## NO. SI 42-220

FAA Airworthiness Directive No. 2017-15-09

#### **Airworthiness Directives; Diamond Aircraft Industries GmbH Airplanes**

**2017-15-09 Diamond Aircraft Industries GmbH:** Amendment 39-18969; Docket No. FAA-2017-0640; Directorate Identifier 2017-CE-020-AD.

Figure 1 to paragraph (f)(1)(ii) of this AD:  
 Sequence of Actions for Exhaust Clamp Installation of  
 DAI Work Instruction WI-MSB 42-120, Revision 3, dated July 6, 2017

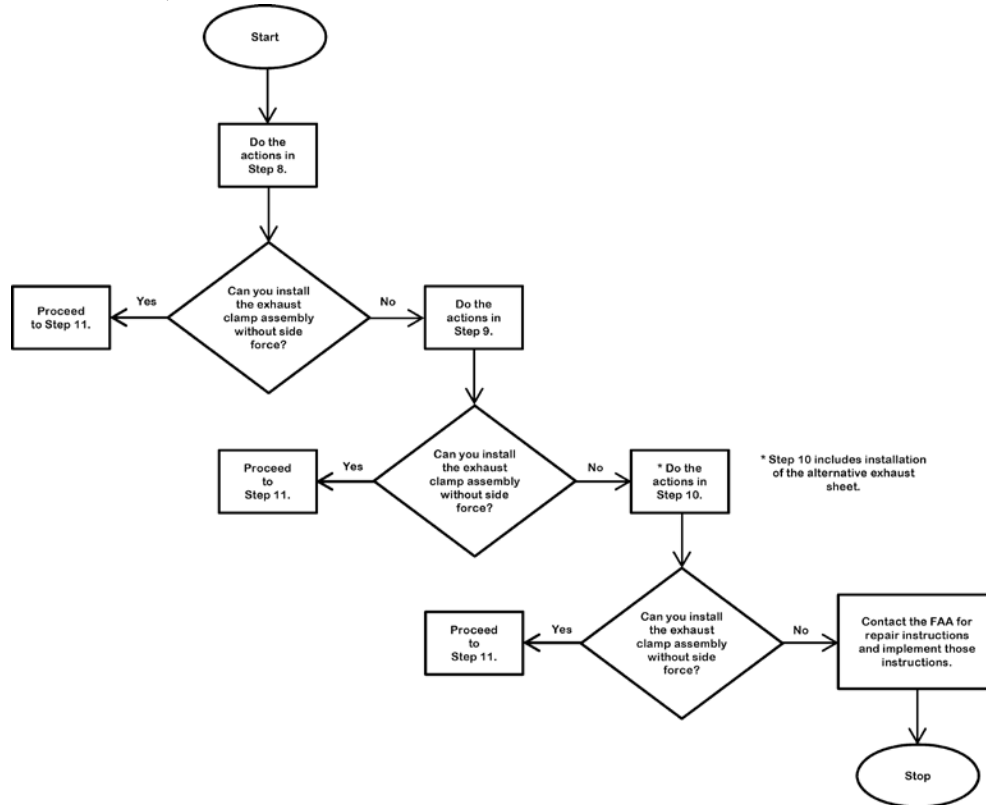
(ii) Reinstall any uncracked clamp or replace with a new clamp and incorporate spring washers following III.2 Action 2—

installation of additional exhaust clamp in the INSTRUCTIONS section of DAI Work Instruction WI-MSB 42-120, Revision 3, dated July 6, 2017, as specified in DAI Mandatory Service Bulletin MSB 42-120/2, dated June 7, 2017. See figure 1 to paragraph (f)(1)(ii) of this AD for additional information on the sequence of installation actions as identified in DAI Work Instruction WI-MSB 42-120, Revision 3, dated July 6, 2017. Credit is not given for installation of an engine exhaust clamp installed following DAI Work Instruction WI-MSB 42-120, Revision 1, dated December 14, 2016, (installation of exhaust clamp without spring washers), or DAI Work Instruction MSB-42-120, Revision 2, dated June 7, 2017.
